South Texas Project
Units 1 & 2
Docket Nos. STN 50-498 & 50-499
Reactor Vessel Material Surveillance Capsule Removal - Revision

**SOUTH TEXAS PROJECT
UNITS 1 AND 2
REVISED REACTOR VESSEL MATERIAL
SURVEILLANCE CAPSULE REMOVAL**

SURVEILLANCE CAPSULE LOCATIONS IN REACTOR PRESSURE VESSEL

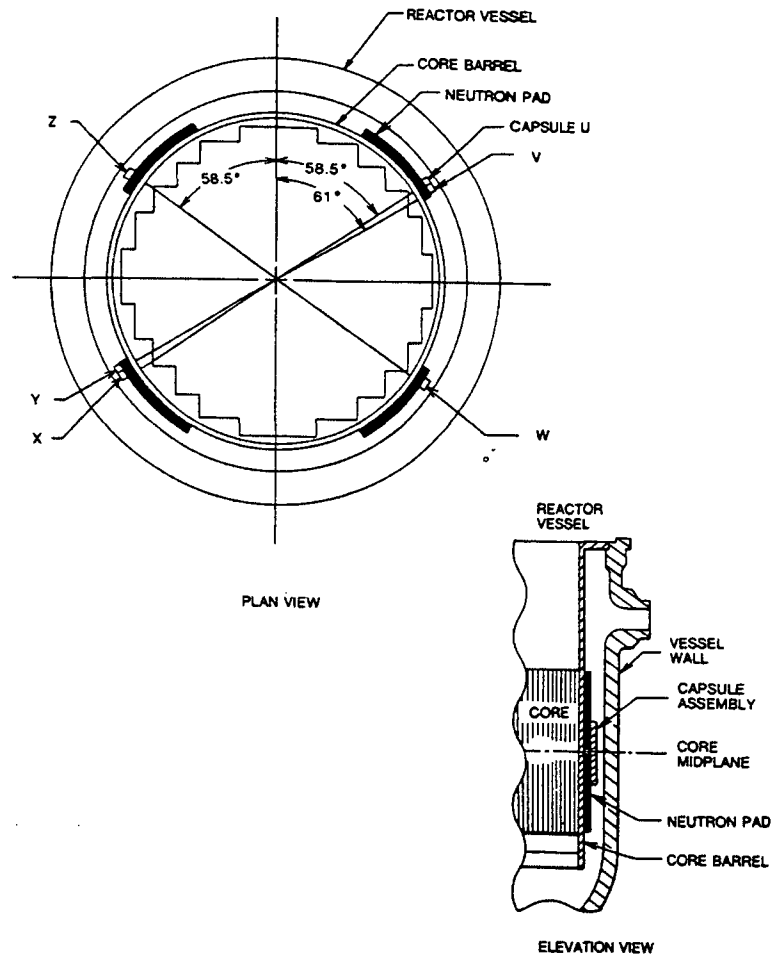
Equipment in place around the reactor pressure vessel needed to conduct a refueling operation block access to the location where capsule X is positioned. Achieving access requires that equipment be repositioned, a process that makes capsule removal a critical path activity and potentially lengthening the duration of the refueling outage. Achieving access to capsule W for removal is not a critical path activity.

There are three surveillance capsules remaining in each reactor pressure vessel (X, W, and Z). See the attached figure. STPNOC has submitted an application to the NRC to extend the licensed operating life of the Unit 1 and 2 (reference 3). Capsule X (both units) was intended to be the source for data to qualify operation for 60 years to support license renewal for the extended plant life. Capsule X was initially chosen because it has the highest lead factor of the three remaining capsules in both units (Table 2). However, the difference between lead factors for X and W is not significant (about 1%).

One surveillance capsule per unit will be withdrawn during 1RE16 and 2RE15. Capsule W will be pulled instead of capsule X. The surveillance specimens will have been exposed to neutron fluence for an estimated 18 EFY by that time. This withdrawal campaign is depicted in the attached STP UFSAR Table 16.1-2, "Reactor Vessel Material Surveillance Program – Withdrawal Schedule." The remaining capsules will be left in place pending further determination.
